Service Bulletin #189

SUBJECT: THROTTLE CABLE ADJUSTMENT SCREW TENSION SPRING
A65-2L - A50-2C AND A50-2CC MODELS

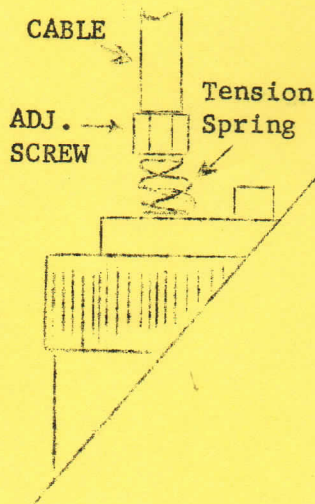
A tension spring can be assembled on the throttle cables on the dual carburetor models to prevent them from getting out of adjustment after they are set properly.

1. Remove the top from the body of the carburetor.
2. Remove the throttle slide clip from the end of the cable.
3. Pull the cable out of the slide, spring and carburetor top.
4. Remove the adjusting screw from the carburetor top.
5. Slide the tension spring over the adjusting screw and assemble it back into the carburetor top.
6. Reassemble the throttle slide spring, throttle slide and cable clip.
7. Reassemble the throttle slide into the carburetor body and tighten the carburetor top in place.
8. Adjust the throttle cables to obtain even idling on both cylinders. See the Amal Leaflet, List No. 102/3 for detailed instructions on Timing Twin Engines with Dual Carburetors.

<u>LIST</u>
2	4/148	Tension Spring (one for each throttle cable)	.15 ea.
		(One or more coils can be ground off if the spring is too long.)
